## LiDAR Quality Assessment Report

UT\_GSLMiddle\_2011

This data set created using LiDAR points collected from airborne surveys completed between October 10, 2011 and October 12, 2011 and covers approximately 83 square miles contained in the following county(s): Weber County, Utah; Davis County, Utah.

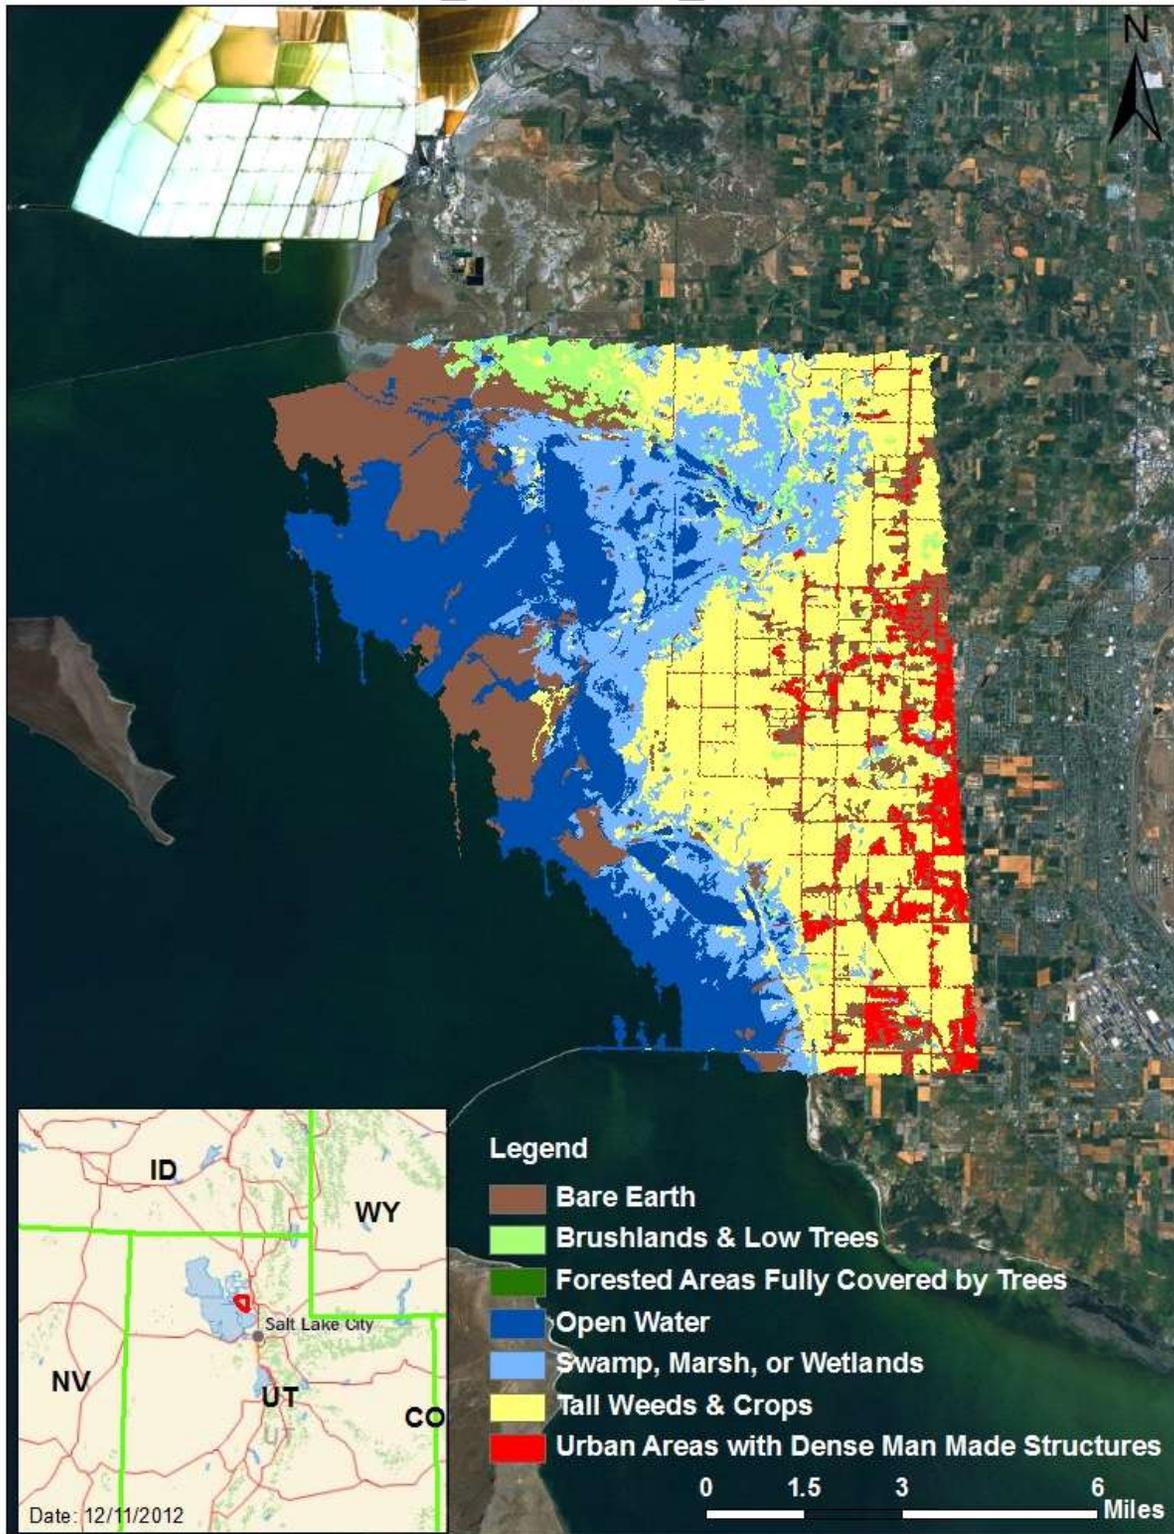
within each class are uniformly distributed throughout the dataset. USGS was notable to locate independent checkpoints for this analysis. USGS does not accept at this time the quality of the checkpoint data for these LiDAR datasets.

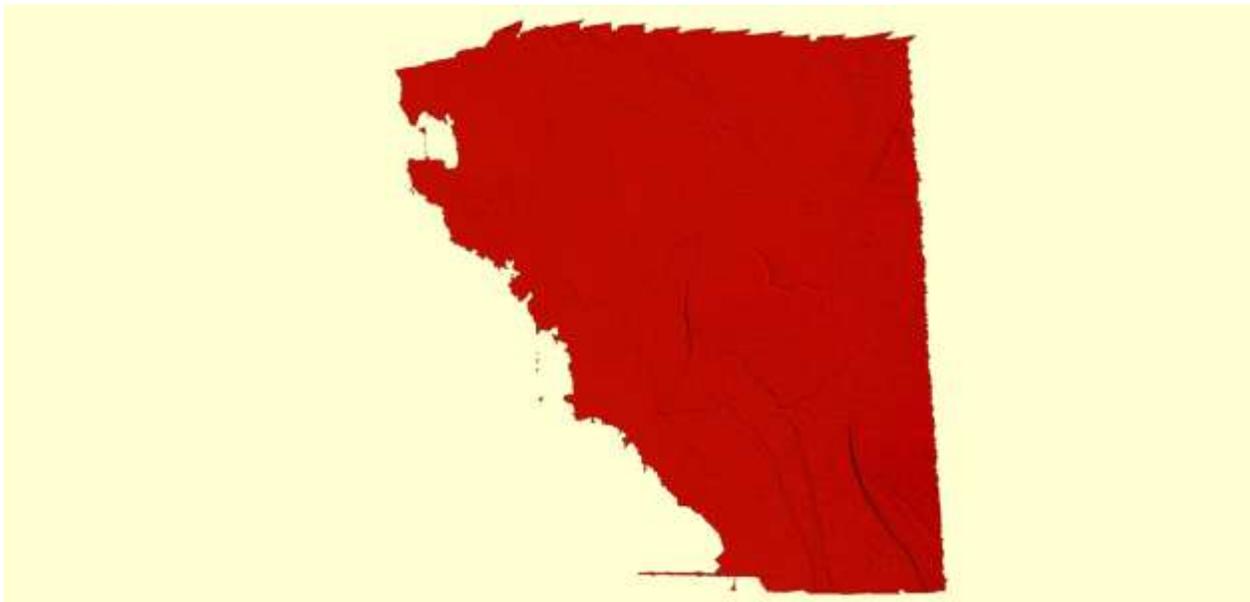
DEM Tiles do not Perfectly Conform to the Tiling Scheme in Terms of Quantity, i.e., 80 DEM Tiles out of a Tile Scheme of 83 Tiles. Missing DEM tiles are: [GSL\\_Middle\\_000039](#), [GSL\\_Middle\\_000063](#), and [GSL\\_Middle\\_000070](#). These missing tiles do not contain significant data and their absence is acceptable.

Mosaic of original DEM tiles above, there were issues surrounding the edge relating to density, tinning, and extent mismatch.

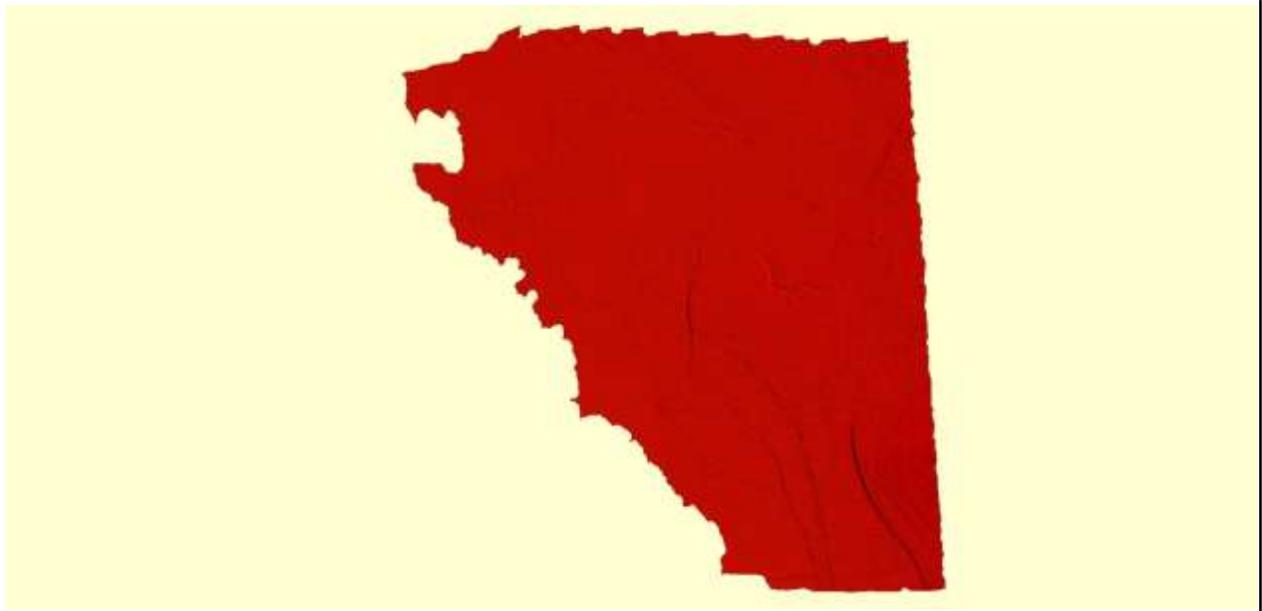
In order to make the DEM usable in the 1/9th NED the project was buffered in by 100 Meters and cut out on the southern portion to ensure there were no gaps in the data due to the flight lines. The final product sent to the NED should be free of data voids and have adequate point density for gridded areas included in the final mosaicked DEM. This also has an accompanying DEM Project Footprint and is 79.71 SqMi.

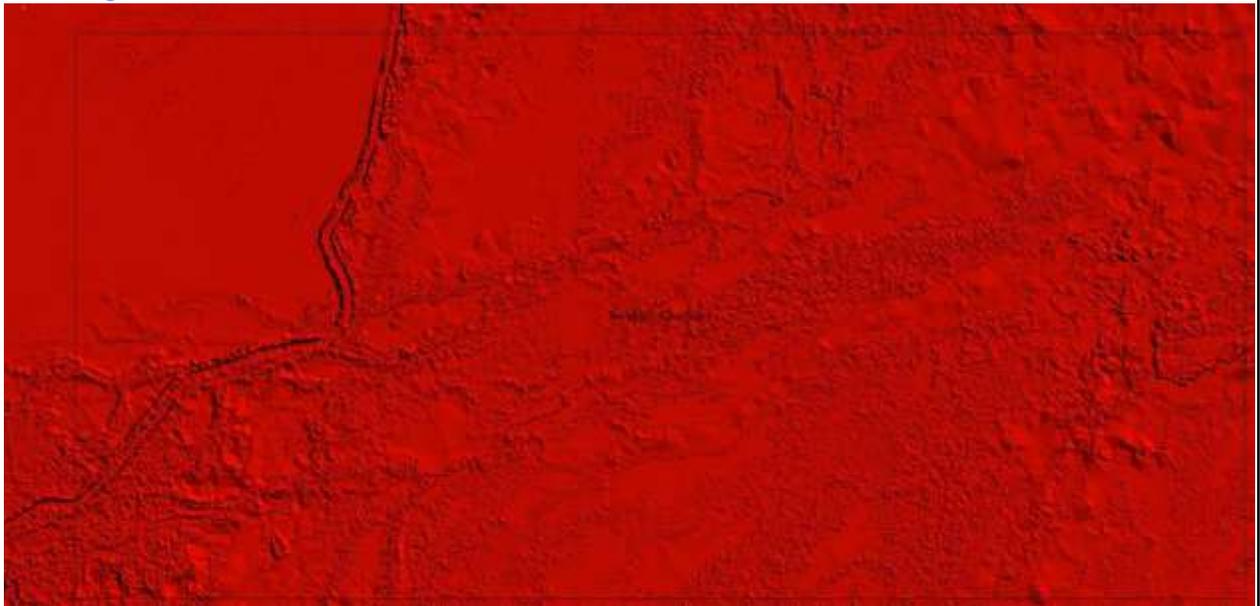
Many Water/Swamp areas exhibit tinning or stair stepping, it is evident that some form of hydro treatment was done in certain areas, however they are not a completely flat surface. Greater familiarity with the area would be required to make Swamp v. Water leveling treatment recommendations for the areas in question.
